CHATHAM COUNTY PURCHASING DEPARTMENT

ADDENDUM NO. 2 TO BID NO.17-0009-4

FOR: HUTCHINSON ISLAND BULKHEAD REHABILITATION

WATER SPLICE USE FOR TOP & BOTTOM

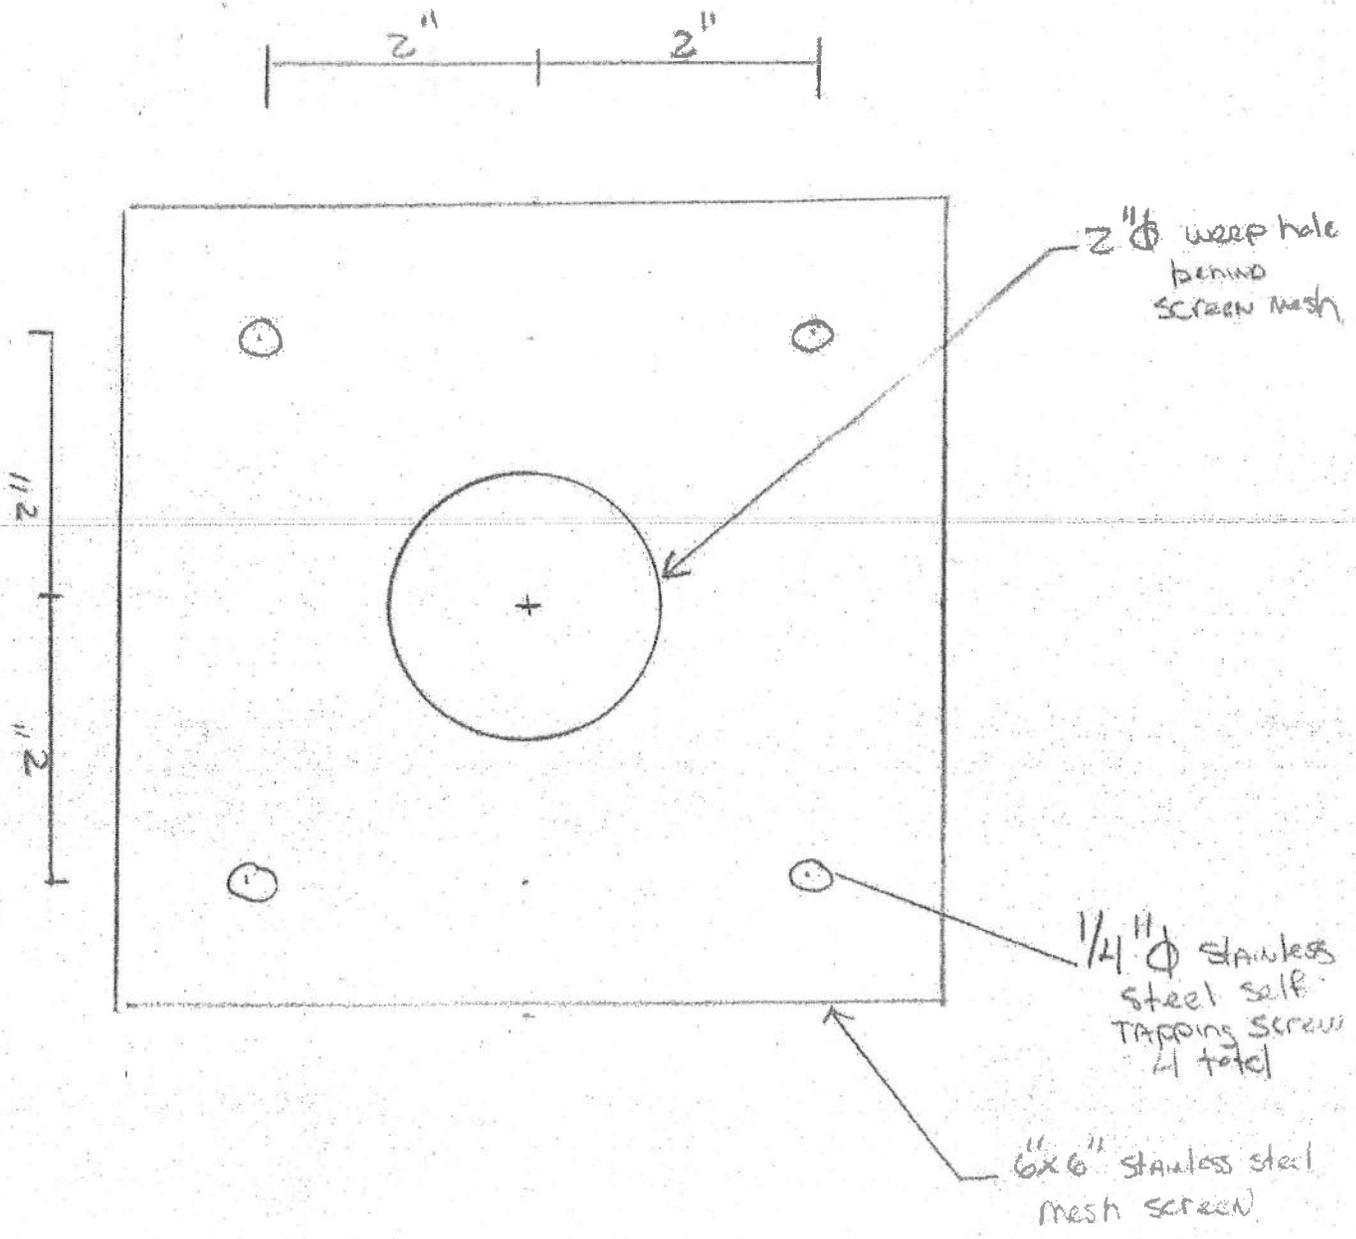
8. Please provide a typical section of a front view at the sea wall showing extents of channel whaler. Is the channel whaler continuous? If continuous, please provide splice details. *A) Channel Whaler is continuous. See attached sketch for splice.*

splice channel
 C6x13xL=1'-0" FOR COLLINS WATER
 w/ 4-3/4" A325 Bolts each side

splice channel
 C10x30 x L=1'-6" FOR COLLINS WATER
 w/ 6-3/4" A325 Bolts
 12 each side
 12 Bolts total

Wire mesh weep hole cover

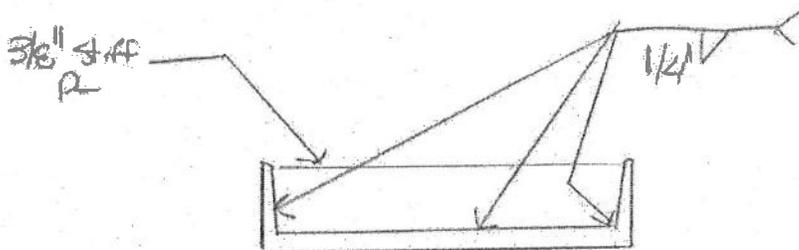
11. Please provide more information on the 6"x6" Stainless Steel Mesh – extents, location, attachment locations/detail/quantity. *A) See attached Sketch.*

St. OFFER Welding Detail

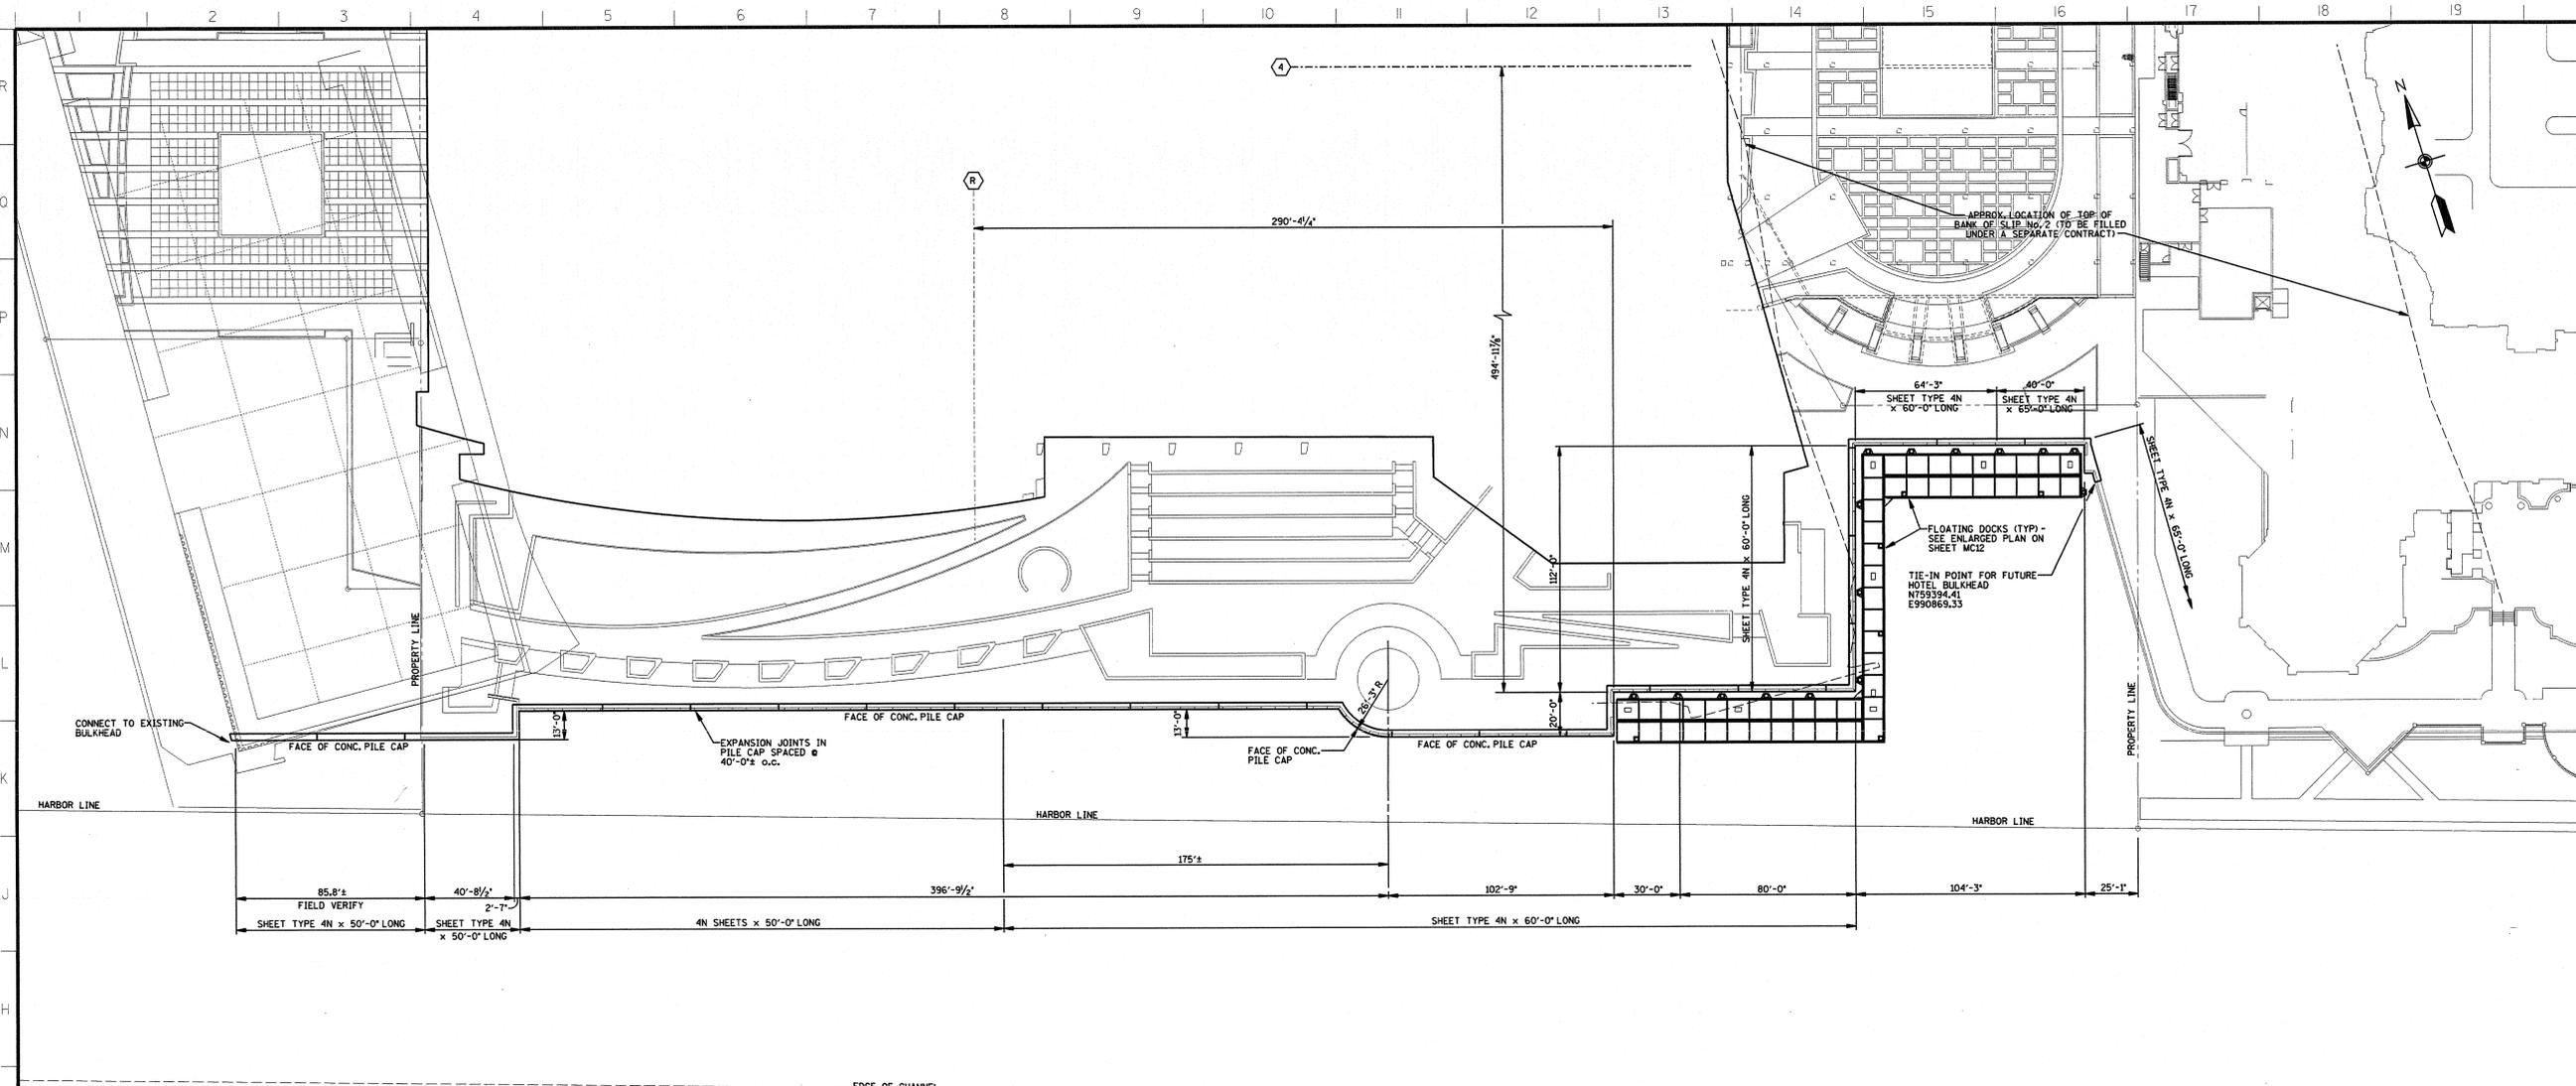
9. Please provide welding details for steel fabrication. *A) See attached sketch.*
10. Please provide elevation and quantity of existing weep holes. *A) Field Verify.*
